Waterview East Commercial  
Traffic Impact and Access Analysis  
PUDSP-22-009  
(LSC #S214970)  
July 11, 2023

LSC  
Responses  
to TIS  
Redline  
Comments

Figure 3  
Site Plan

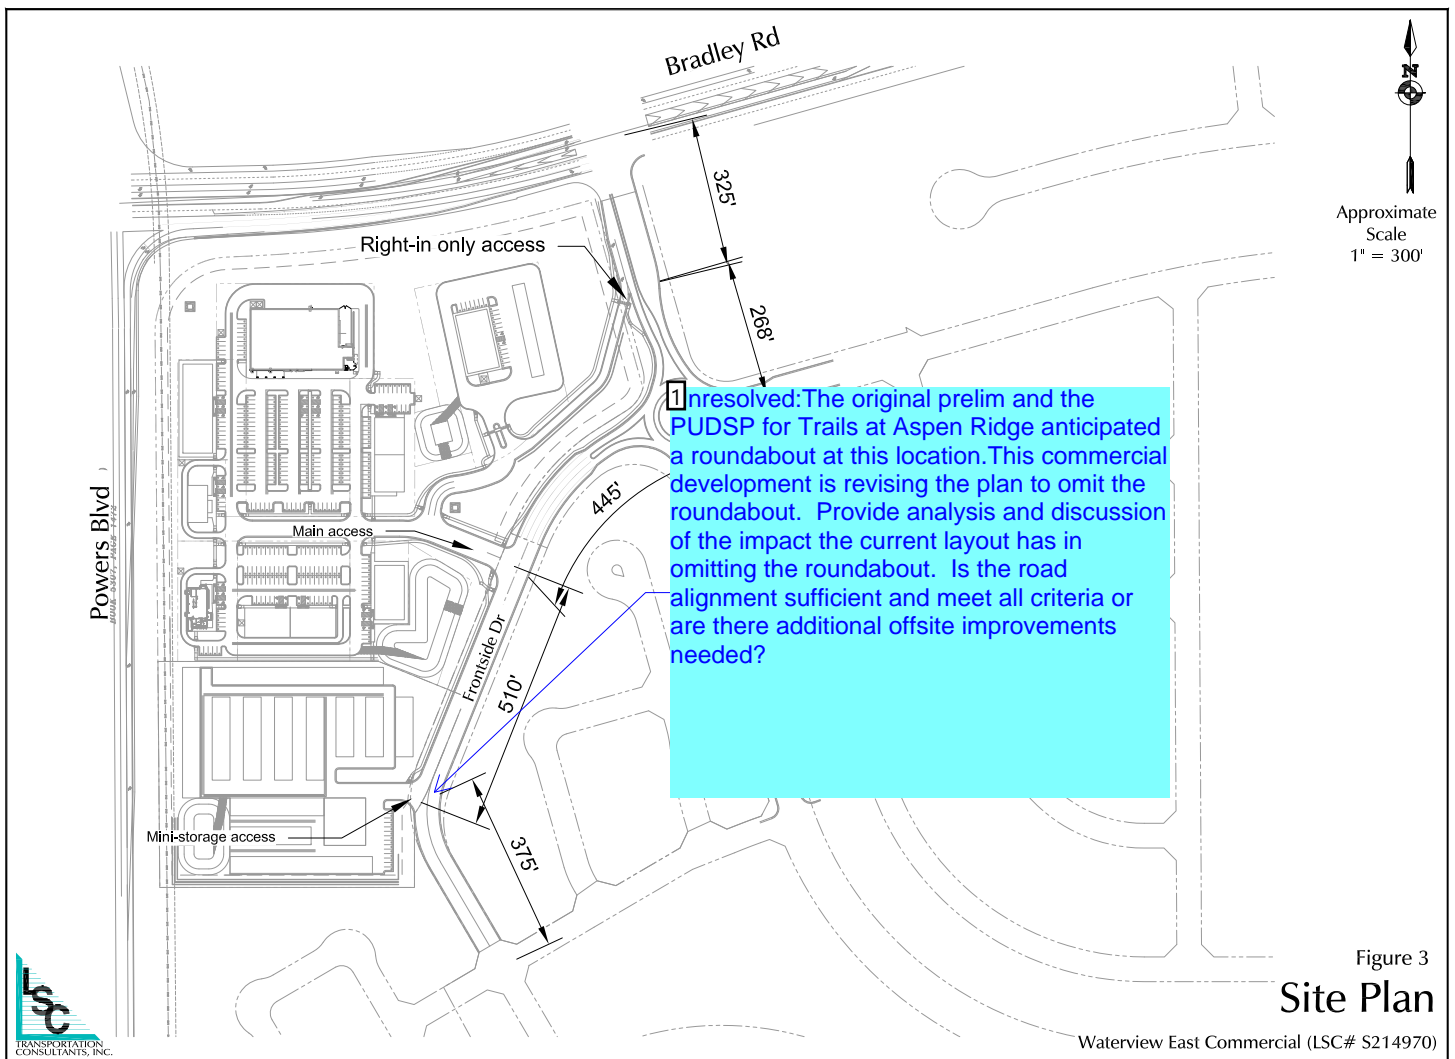
Unresolved Review 2 Comment: The original prelim and the PUDSP <sup>1</sup> for Trails at Aspen Ridge anticipated a roundabout at Frontside Drive. This commercial development is revising the plan to omit the roundabout. Provide analysis and discussion of the impact the current layout has in omitting the roundabout. Discuss traffic patterns/counts and compare to submitted TIS done in the area. Provide documentation that this development has contacted the developer for Trails at Aspen Ridge regarding the modification. Final plats associated with TAR show a proposed roundabout and account for that in their TIS.

Unresolved Review 2 Comment: The original prelim and the PUDSP for Trails at Aspen Ridge anticipated a roundabout at Frontside Drive. This commercial development is revising the plan to omit the roundabout. Provide analysis and discussion of the impact the current layout has in omitting the roundabout. Discuss traffic patterns/counts and compare to submitted TIS done in the area. Provide documentation that this development has contacted the developer for Trails at Aspen Ridge regarding the modification. Final plats associated with TAR show a proposed roundabout and account for that in their TIS.

LSC Response: Per a phone conversation between J. Hodsdon and Ms. Durham on August 14, 2023, the report has been revised to include an additional item in the "DEVIATIONS" section of the updated TIS to address this comment and removal of the roundabout. This additional text reads as follows: "

*Note: a deviation may be required for the centerline curve radius on Frontside Drive near the south site access. Although the above explains how the south portion of Frontside Drive can be considered a "transition section" to the Urban Local street to the south (note: that the local street radius standard is 200 feet), the standard centerline radii is 565-feet on a Non-Residential Collector street. The Preliminary Plan shows a 200' radius. After a brief discussion with staff on August 14th, it was agreed that a deviation, if needed, be prepared later in conjunction with the design of Frontside Drive. It our understanding that the Trails at Aspen Ridge developer is responsible for the design of Frontside Drive as part of the final plat of the adjacent land. Any required, associated deviations would be submitted at that time, with the plat and/or street design plan submittal.*

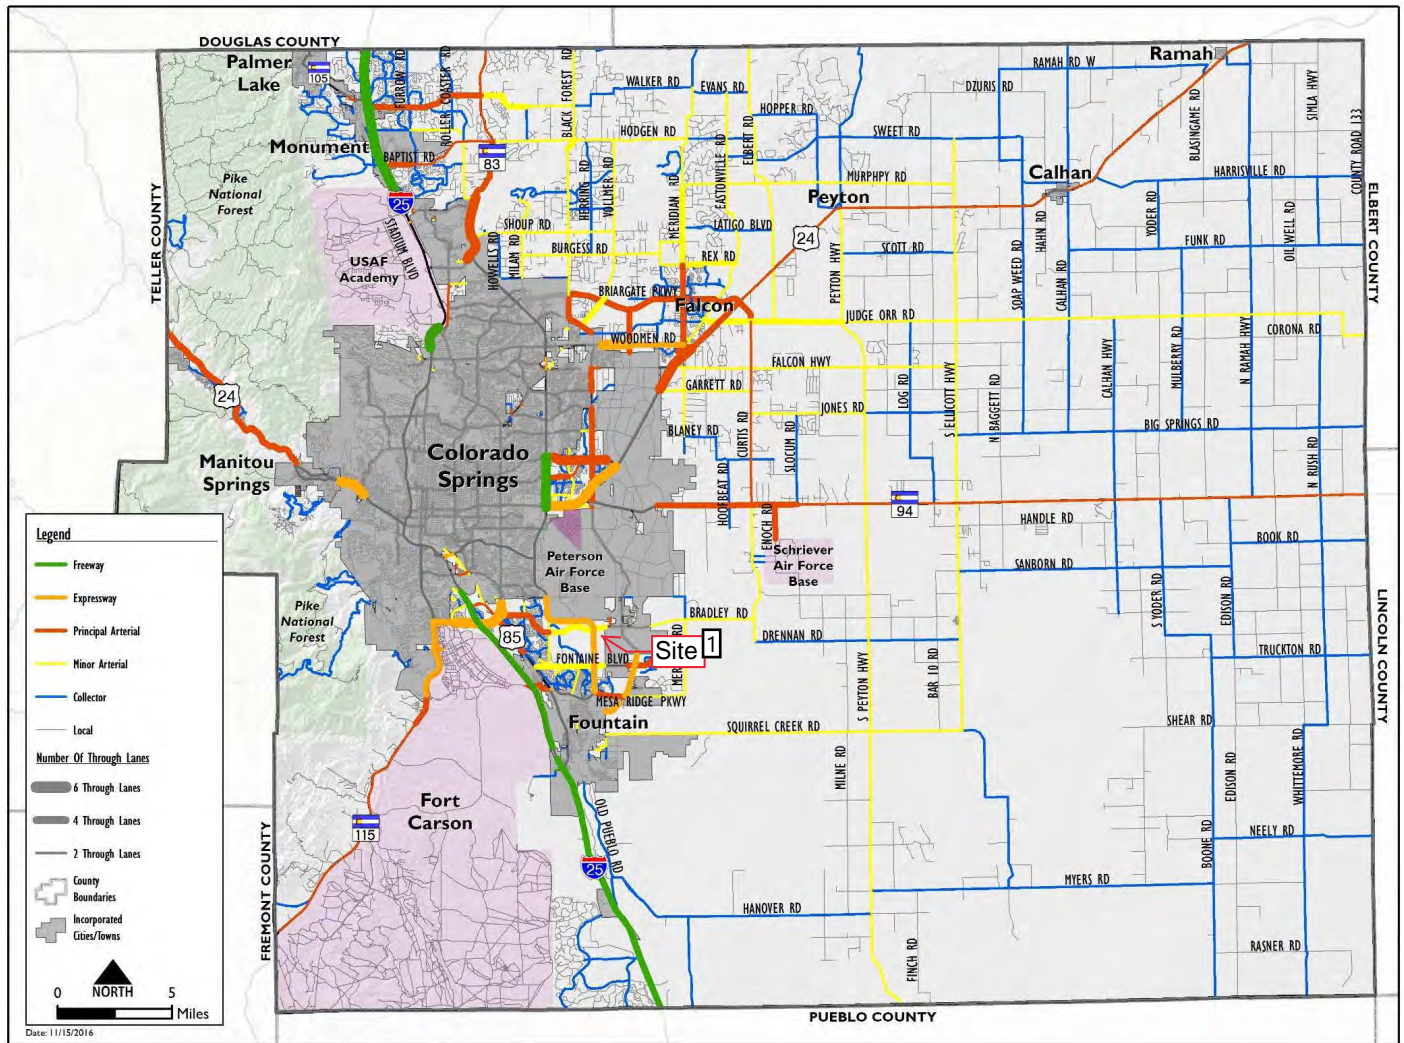
Unresolved: The original prelim and the PUDSP for Trails at Aspen Ridge anticipated a roundabout at this location. This commercial development is revising the plan to omit the roundabout. Provide analysis and discussion of the impact the current layout has in omitting the roundabout. Is the road alignment sufficient and meet all criteria or are there additional offsite improvements needed?

Author: jchodsdon      Subject: Sticky Note      Date: 8/15/2023 1:09:07 PM  
LSC Response: Please refer to the response to the above comment.
